Service Bulletin

Bulletin No. 2017-05R1

2.5L and 3.0L Air Compressor Reed Failure

NOTICE
Revised June 2017. This bulletin supersedes the previous bulletin number 2017-05 March 2017.

Air compressor

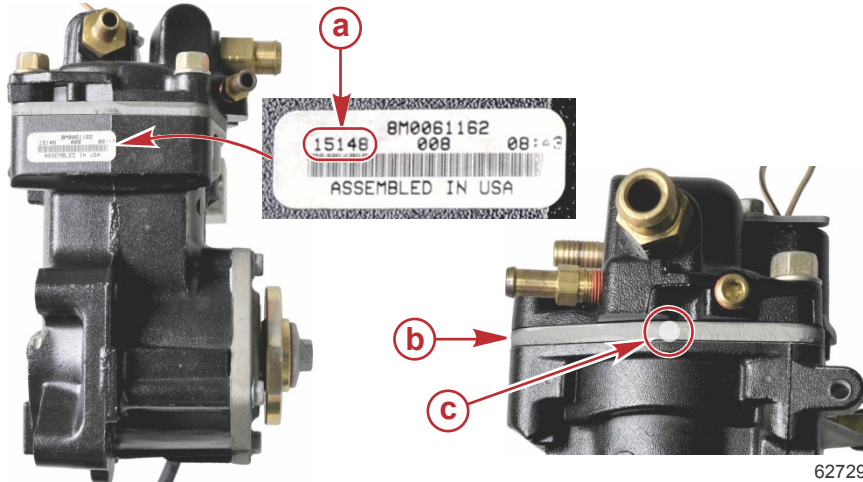
IMPORTANT: A white dot on the edge of the reed plate assembly indicates the reed plate assembly has been replaced. Do not rework a compressor with a white dot on the edge of the reed plate assembly.

Check the engine to confirm whether the air compressor is an affected unit. If no white dot is present and the engine serial number falls within the range specified at the top of this service bulletin, replace the reed plate assembly.

Inspect all in-stock replacement air compressors. If no white dot is present and the Julian date code falls between 14189 (July 8, 2014) and 16246 (September 2, 2016), inclusive, replace the reed plate assembly.

- a - Julian date code; codes 14189 through 16246 are affected
- b - Reed plate assembly
- c - White dot indicating that the reed plate assembly has been replaced and is not affected

Reed plate assembly

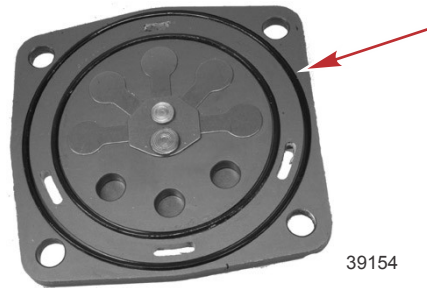
Reed plate assembly, p/n 835088A10.

Port Fuel Rail Disengagement (2.5L Only)

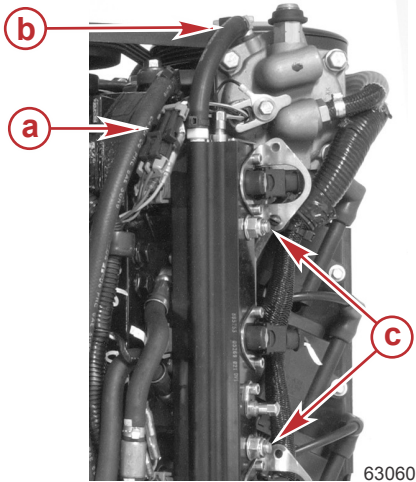
In order to access the lower left-hand screw on the air compressor cylinder head on 2.5L models, the port fuel rail must be temporarily disengaged and moved out of the way.

1. Disconnect the cylinder head temperature sensor harness connector.
2. Disconnect the compressor water inlet hose.

3. Remove the two fuel rail mounting nuts.

- a - Cylinder head temperature sensor harness connector
- b - Compressor water inlet hose
- c - Fuel rail mounting nuts (2)

4. Without removing the lower cowl, position the fuel rail out of the way, and complete the reed plate assembly replacement. Before putting the engine back into service, be certain to reconnect all items and tighten the fuel rail mounting nuts to the specified torque.

Reed plate assembly edge marked with a white dot

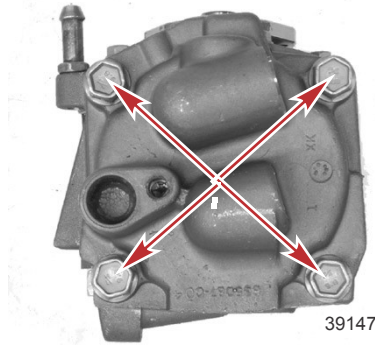
- To indicate that the rework procedure has been completed, mark the top edge of the replacement reed plate assembly with a white dot.
